# Access Compliance Report

## Public Rights-of-Way

Intersection ID: 3373	Main Street: KATELYN_DR	Cross Street: PROSPERITY_CHURCH_RD	Location:	N
ADA ID: 2D5B8C0A504D	Ramp Type: Perp	Initial Pass/Fail: Fail	Overall Compliance: No	Severity Score: 46.25

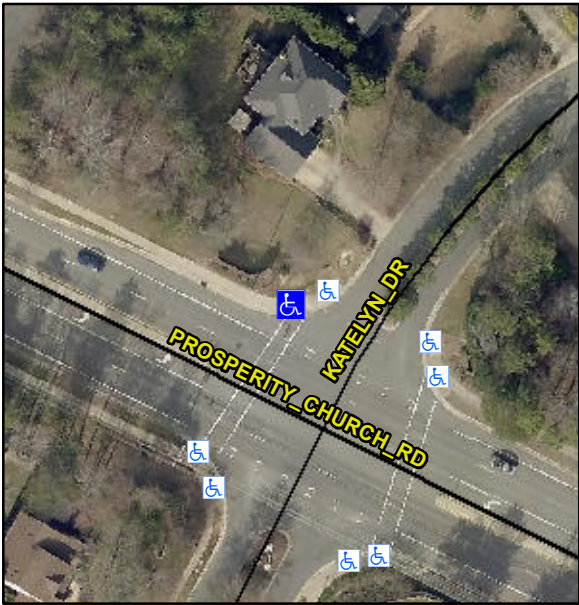
Codes/Mitigation Info/Possible Solution			Field Measurements/Component Compliance									
	Possible Solutions:		<b>Compliance</b>			<b>Description</b>			<b>Data</b>			
	<b>Remove &amp; Replace Entire Ramp.</b>		<b>N/A</b>	Ramp Length (in)		<b>72.0</b>	<b>No</b>	Ramp Slope (%)		<b>19.4</b>		
			<b>No</b>	Ramp Width (in)		<b>42.0</b>	<b>No</b>	Ramp XSlope (%)		<b>6.0</b>		
			<b>N/A</b>	Flare Type LT		<b>N/A</b>	<b>N/A</b>	Flare Type RT		<b>N/A</b>		
			<b>N/A</b>	Flare Slope LT (%)		<b>N/A</b>	<b>N/A</b>	Flare Slope RT (%)		<b>N/A</b>		
			<b>N/A</b>	Flare Traversable LT?		<b>N/A</b>	<b>N/A</b>	Flare Traversable RT?		<b>N/A</b>		
			<b>N/A</b>	Landing Length (in)		<b>N/A</b>	<b>N/A</b>	DWS Provided?		<b>N/A</b>		
			<b>N/A</b>	Landing Width (in)		<b>N/A</b>	<b>N/A</b>	DWS Contrast?		<b>N/A</b>		
			<b>N/A</b>	Landing Slope (%)		<b>N/A</b>	<b>N/A</b>	DWS Length (in)		<b>N/A</b>		
			<b>N/A</b>	Landing X Slope (%)		<b>N/A</b>	<b>N/A</b>	DWS Full Width?		<b>N/A</b>
